# Problem B: Power and Timing Optimization Using Multibit Flip-Flop

Sheng-Wei Yang, Tzu-Hsuan Chen, Jhih-Wei Hsu, Ting Wei Li, Cindy Shen (Synopsys, Inc.)

# Q&A

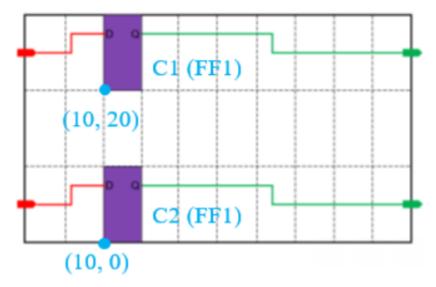
NumInstances 2

Inst C1 FF1 15 20 -> Inst C1 FF1 10 20

Inst C2 FF1 15 0 -> Inst C1 FF1 10 0

- 3. (1) Yes
  - (2) It depends on the dimensions of BinWidth and BinHeight.
  - (3) Max placement utilization ratio defined in this contest divides the Die Area of the design into bins whose dimensions are (BinWidth, BinHeight). The first bin starts from (<lowerLeftX>, <lowerLeftY>) of DieSize, and repeats with (BinWidth, BinHeight) throughout the DieSize.
- 4. Yes, the cell height may be n \* row height (n is an integer and n >= 1).
- 5. Please refer to the Evaluation part. Each cell needs to be placed on site and no cell could be placed overlapping another.
- 6. We have revised the problem formulation and orientation is not considered in this contest.
- 7. Yes, you are right. It should be 10. We will revise the statements.

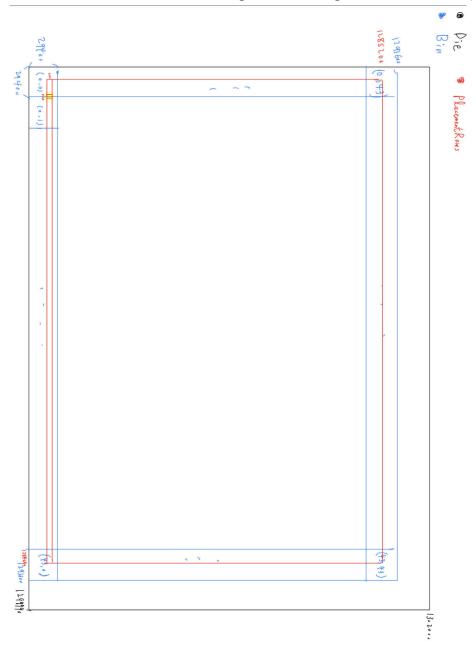
**Q24.** The naming convention for the pins of multi-bit flip-flops is a bit unclear to us. For the D pins, is the naming sequence simply D0, D1, D2, and so on? Is it similar to the Q pins as well? Does Di correspond to Qi? Is the clock pin conventionally named CLK? Additionally, is there a way to tell from the pin names of a combinational gate whether they are input or output? For example, in the documentation, the examples are named IN and OUT.

Regarding the slack example, when there is only one path, how should we calculate slack if multiple Q pins are connected to one D pin? Should we take the sum or the maximum? If we take the maximum, how can we determine which is the critical path?

**A24.** FlipFlop has Q0, Q1, Q2, ..., D0, D1, D2, ... etc. Di is corresponding to Qi. Clock pin is conventionally named CLK or clk. You can tell a combinational gate's pin name by its prefix. It would be IN\* or OUT\*, in either upper or lower case.

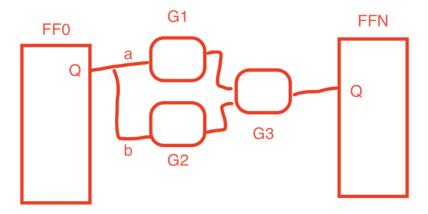
and then connected to a flipflip's fanin is common for every circuit. This problem will severely affect our calculations on Timeslack. Can you give an example of finding the critical path of timeslack?

**A44.** There could be multiple paths. If a gate has multiple inputs, the delay is dominated by the latest arrival time of each signal. Please refer to Q16.

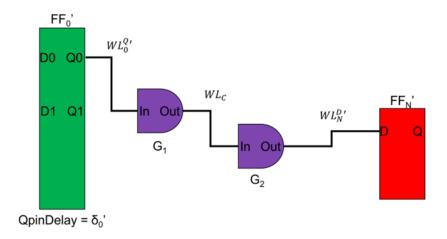
3. In the latest material, the slack is calculated as follows. Assuming that the slack of FF0 is large, the slack of FFN is large(100, for example), too, but the distance between FF0 and FFN is small. According to the formula, the new slack of FFN' is calculated without considering the slack of FF0' but the position of FFN', so even if the slack of FF0' is negative, it is independent of the slack of FFN', and the slack of FFN' can still be close to 100. Do I understand correctly?

$$S_{FFN}' = S_{FFN} + (\delta_0 - \delta_0') + DisplacementDelay * (WL_0^Q - WL_0^{Q'}) + DisplacementDelay * (WL_N^D - WL_N^{D'})$$

$$S_{FFN} = S_{FF0} + \delta_0 + DisplacementDelay * (  $WL_0^Q + WL_C + WL_N^D )$$$

#### A45.

- 1. The delay would be dominated by the latest arrival time of each signal. In this instance, G3's delay is dominated by either a or b, depending on which path has the latest arrival time. Please refer to Q16.
- 2. Take the latest arrival time as the delay to calculate the slack.
- 3. Please refer to Q16 as an example. The slack of FFN' would still be affected by the differences from FF0 to FF0'.
- **Q46**. Could you please tell us where TimingSlack is used in the problem? Could you provide an example?
- **A46**. The final score calculation involves the negative Dpin slack. For example, if one Dpin has an initial timing slack 5. After your banking/debanking operations, the arrival time of that Dpin is increased by 6, thus Dpin slack changes to −1, then it will contribute the penalty when scoring. On the other hand, it's possible to fix a violating Dpin by decreasing the arrival time.

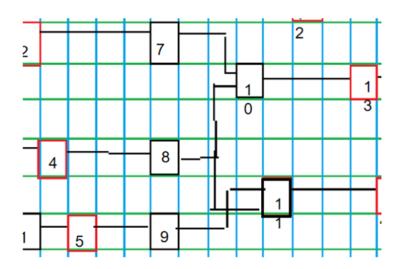
**Q50.** How do we determine the slack when a FF has multiple ancestor FFs? As depicted in the figure.

**A50.** The final slack of FFN/D is decided by two timing paths:

- 1. FF0/Q -> G1/IN->G1/OUT->G2/IN1->G2->OUT->FFN/D
- 2.  $FFbottom/Q \rightarrow G2/IN2 \rightarrow G2 \rightarrow OUT \rightarrow FFN/D$

The arrival time of G2/OUT = max(Arrival(G2/IN1), Arrival(G2/In2))

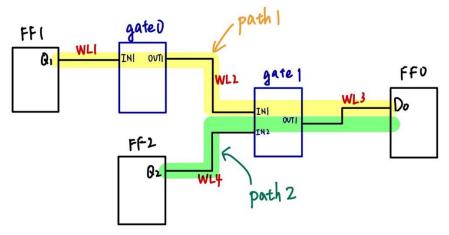
2. in samplecase line6~8 is input cell library

```
6 NumInput 2
7 Input in 8344 22840
8 Input clk 0 1970
42 Net clk 5
43 Pin CLK
44 Pin reg4/CLK
45 Pin reg2/CLK
46 Pin reg1/CLK
```

so in line 43 should be change to "Pin clk"?

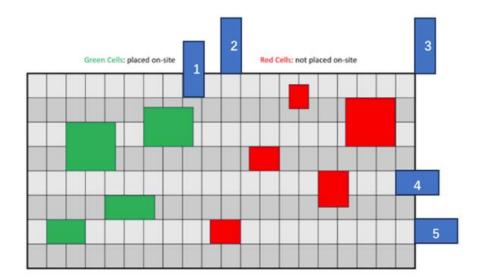
2. In QA64.4 and QA70, you mentioned that there is no need for cells to be enclosed within PlecementRows. To ensure my understanding is correct, I have made some supplements based on the examples in the document, as shown in the following figure. May I ask which of the 5 blue cells are legal? (Assume that all of them are within die region)

- (2) The area of any cells should not exceed the die area. Therefore, considering that the white space in your figure is outside of the die area. All 5 blue cells are illegal. That being said, if all 5 blue cells of yours are in the die area (i.e. if the white space in your figure is in the die area), Cell 1, 4 and 5 are legal as they are not required to be enclosed within PlacementRows and their bottom-left corners all align with the site grids. The bottom-left corners of Cell 2 and 3 are not aligned with the site grids but above the site.

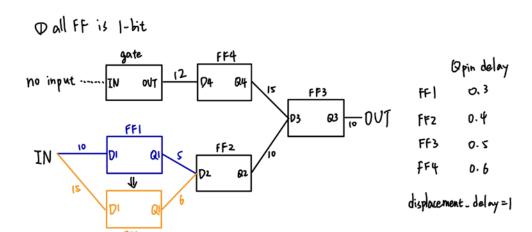
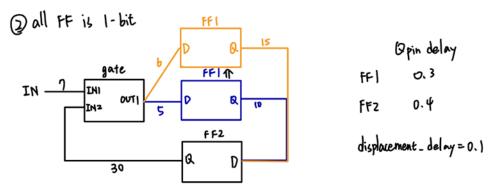
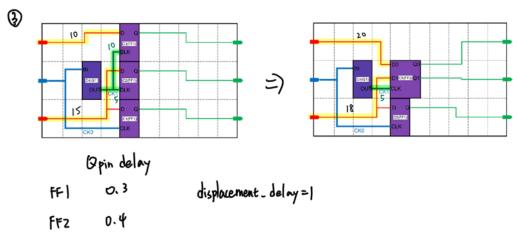
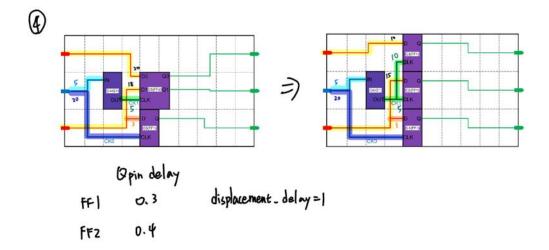
**Q89.** We have noticed some discrepancies between our calculations and your TNS-related calculations. Therefore, we would like to clarify the correct methodology using the following four cases. We would appreciate it if you could provide a detailed calculation process (specific numerical calculations, which formula was used, and the reason) for calculate the updated slack for each flip-flop (FF) for each of these four cases.

(1) The first case involves a gate with no inputs and what constitutes a starting level flip-flop (FF). All the numbers on the diagram represent wirelength. The initial slack for all FFs is -5. If we move the original blue FF to the position of the orange FF, how will the slack change?

(2) The second case concerns FFs with loops. All the numbers on the diagram represent wirelength. The initial slack for all FFs is -5. If we move the original blue FF to the position of the orange FF, how will the slack change?

(3) The third case is related to Banking. All the numbers on the diagram represent wirelength. The initial slack for all FFs is -5.

(4) The fourth case is related to Debanking. All the numbers on the diagram represent wirelength. The initial slack for all FFs is -5.

- 1. (1) Please use formula 2 to calculate the timing change with displacement. Take FF1's initial slack as SFFN. WLDN is 10, WLDN' is 15. The new slack for FF1 is -5-5=-10. Please calculate the rest using formula 2.
- (2) Please use formula 2 to calculate the timing change with displacement. Take FF1's initial slack as SFFN. WLDN is 5, WLDN' is 6. The new slack for FF1 is -5-1=-16. Please calculate the rest using formula 2.
- (3),(4) Please use formula 2 to calculate the timing change with displacement and take the difference between the Manhattan distance from the driver to the load.

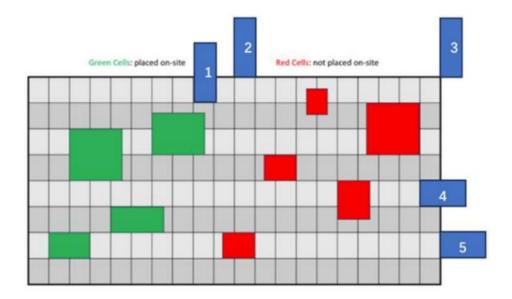
4. My fourth question is, if I move reg1 to a new position (from (5952, 3600) to (6000, 4000)), according to Q72, we need to find the starting point, which is reg1. Will the slack value of reg2 be:

How should the slack value of reg3 be updated based on the change in reg2's slack value? Could you illustrate this using symbols or actual values? When does the information "TimingSlack reg2 D 0.149378" and "TimingSlack reg3 D -0.152106" come into play? Lastly, in what situation is the following formula used?

- 1. TNS stands for total negative slacks. The lower the better.
- 2. Please kindly refer to 4.1 Runtime factor on log<sub>2</sub> computation.
- 3. It is generated by timing analysis tool.
- 4. Changing the position of reg1 does not change the slack of reg3.
